OUTERCOM "Q-T" SQUELCH
INSTALLATION AND SERVICE
INSTRUCTION MANUAL

ADDENDA SHEET

OUTERCOM "Q-T" SQUELCH
INSTALLATION AND SERVICE
INSTRUCTION MANUAL

BASIC Q-T SYSTEM INTERCONNECTIONS

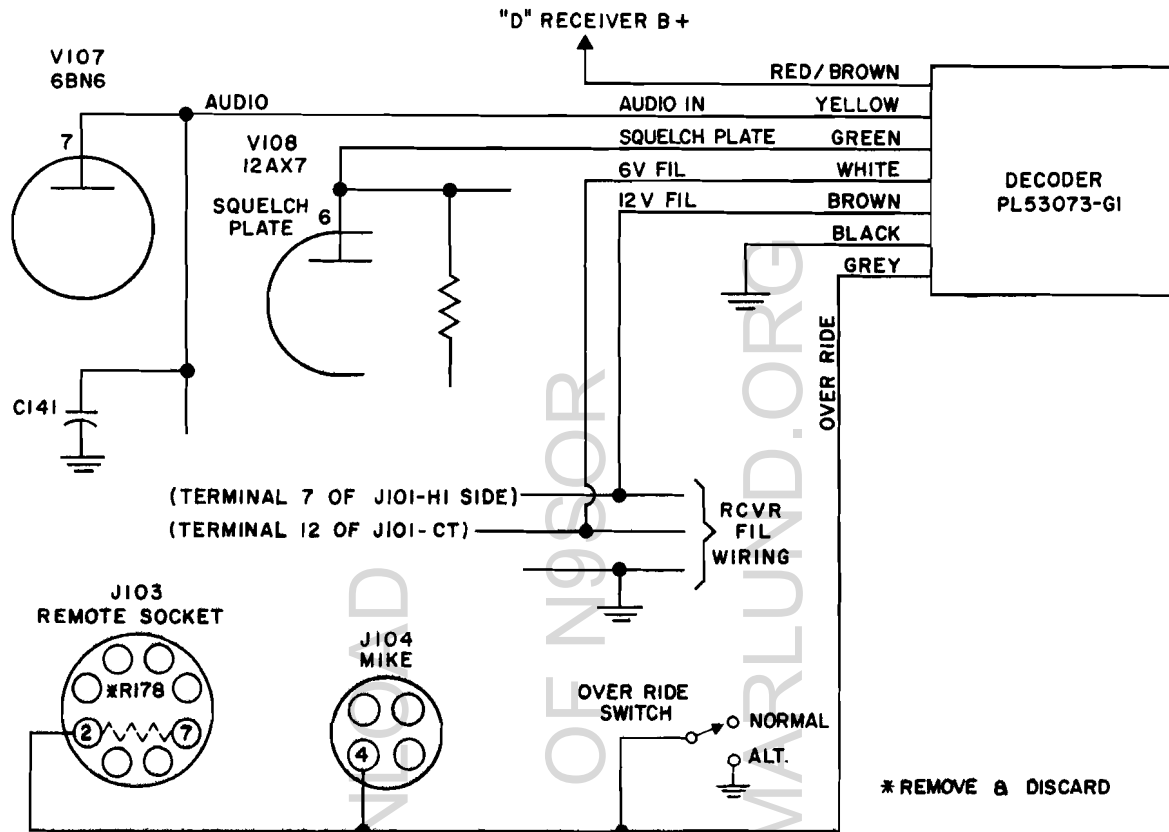
Page 2, Par. D., Item (7). Delete first sentence which reads as follows: "Remove the yellow lead from J104 Pin 4 and tie back."

Add in it's place: "Remove R178 on J103 remote socket". The above is indicated correctly on Schematic No. 53193 Basic Q-T System Interconnections Diagram in rear of manual.
